SECTION 153 OF THE PLANNING ACT 2008
PARAGRAPH 2 OF REGULATION 6 OF THE INFRASTRUCTURE
PLANNING (CHANGES TO, AND REVOCATION OF,
DEVELOPMENT CONSENT ORDERS)
REGULATIONS 2011 (AS AMENDED)

APPLICATION TO MAKE A NON-MATERIAL CHANGE
TO THE FOLLOWING DEVELOPMENT CONSENT ORDER:
M4 (Junctions 3 to 12) (Smart Motorway) Development Consent
Order 2016 SI 863

1. Application Statement

Figure 1 – Previous Operating Regimen

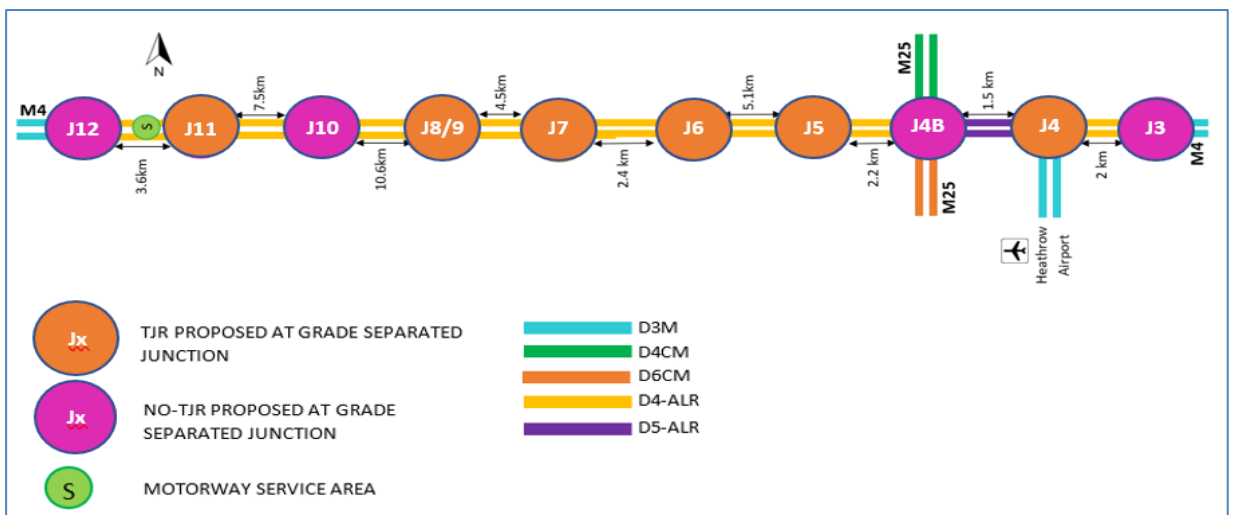
- 5.4. The previous operating regimen which was provided for by the DCO application is shown in Figure 1 and Table 2 below:

Figure 2: Schematic showing layout of junction 6 with TJR in 2015

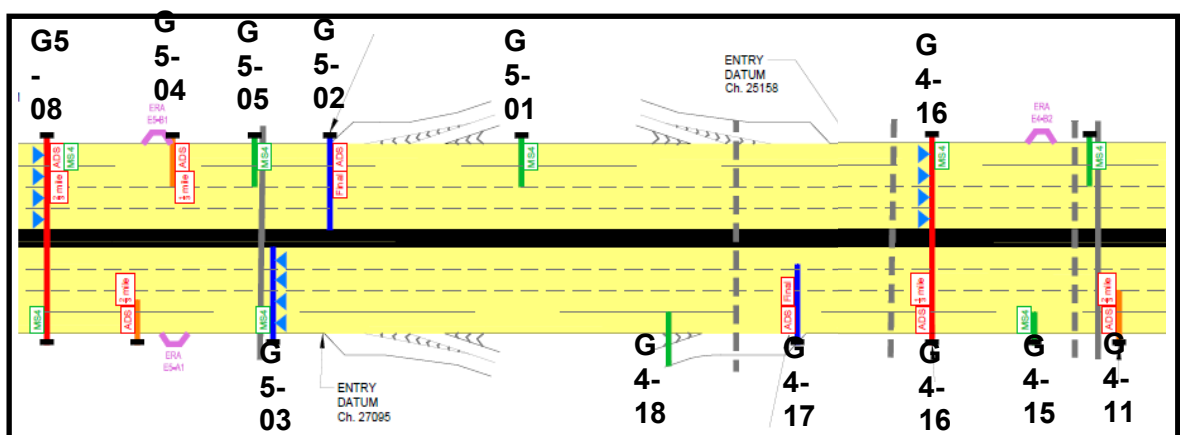
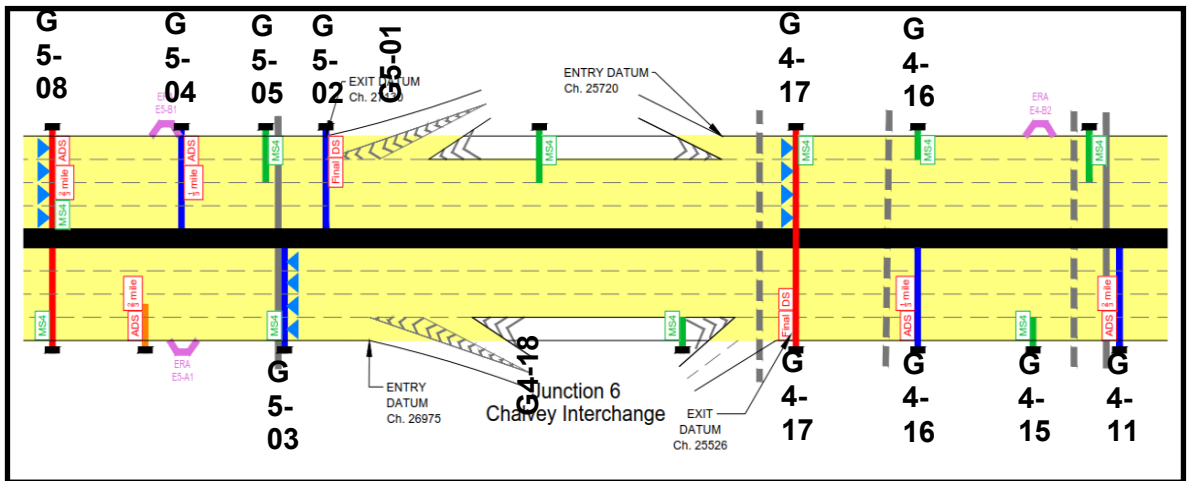
- **Gantries:** Gantry locations are primarily set by the datum point of the merge/diverge lanes at the junction, which have moved as a result of no longer implementing TJR at each of the affected junctions. As a result, some of the gantries associated with the affected junctions require moving, in some locations outside of the limits of deviation for gantries on the Works Plans, thus requiring changes to those plans.

5.17. By way of example, Figure 2 shows a schematic of the previously proposed location/order of gantries on both approaches to junction 6, whereas Figure 3 shows the new proposed layout of junction 6 (with no-TJR).
